**RE: Response to Comments, Bennoc Area NPDES OIL00159 Application for American Energy Corporation in Belmont County, Ohio**

Response to OEPA Comments from Bruce Goff and Eric Nygaard  
Dated 8/21/12, 8/15/12, 7/20/12, 7/13/12, and 7/11/12  
Bennoc NPDES Permit Application  
OIL00159

Wheel treatment system – pictures provided by [www.chemstream.com](http://www.chemstream.com)

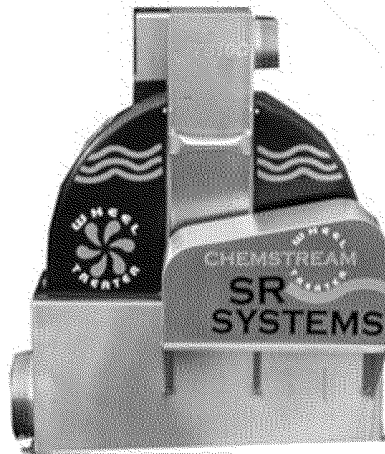
Comment: Do you happen to have any photos of the treatment ponds, the outlet structures, the chemical feed equipment and the discharge drainage ways (outlet ditches) you can share?

Response: We do not have any pictures of the proposed treatment ponds and their structures. However, we do have a picture (below) of the proposed wheel treatment system.

SHEET  
C5

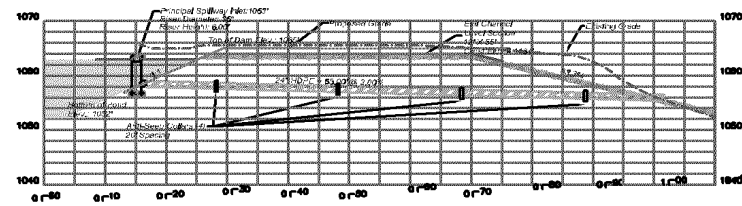
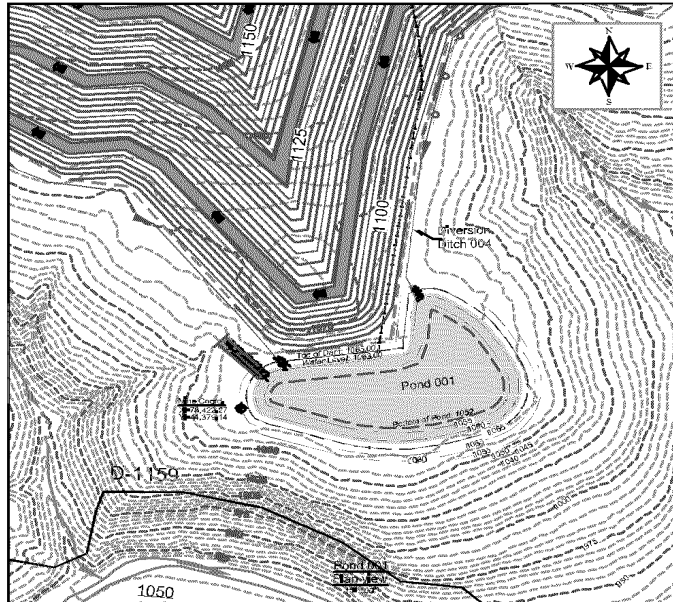
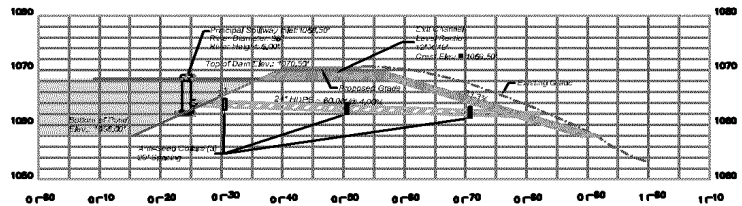
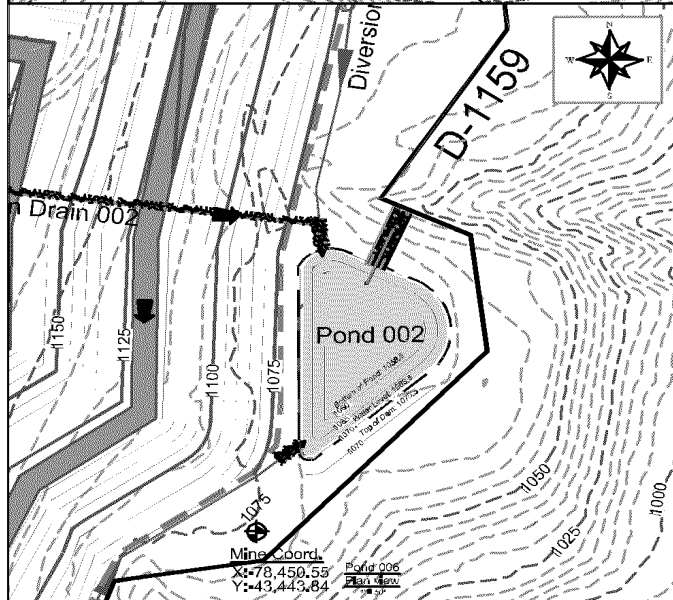
Comment: We do need to see some details of the “enlarged” ponds with this NPDES application to document what the “preferred alternative” is for

treatment. Please submit some details of the pond construction and a general description of the ponds (volume, freeboard, chemical addition equipment, how discharge will be controlled, etc.) as an amendment to the NPDES application/antidegradation addendum.

**Comment:** We need more information about the treatment ponds outlet structures. If the discharges will not occur during dry weather and will be controlled, we need to see the pond outlet structure details showing how this will be accomplished. For example, the ponds shouldn't have an outlet/principal spillway that allows the pond to slowly discharge after it fills. What may be needed is a way to shut off the ponds outlet and have it manually opened to lower the pond water elevation and close it off after a few hours of discharging and repeat this every two weeks or so. Of course the pond would still have the emergency overflow in case of extreme wet weather.

Response: Pond specifications can be found in the attached drawing "Ponds 001 & 002 Data". Chemical treatment will be induced to the pond with the application of ChemStream's wheel treatment system. Further detail of this treatment system can be found in the third response to comments received 7/20/12.

**Response:** The ponds in this application are designed to discharge over a pipe with a riser attached. The only time the pond would be able to top the riser is during wet weather which supplies enough runoff to cause the water to do so. During dry weather, the pond will not receive any inlet flow, due to their
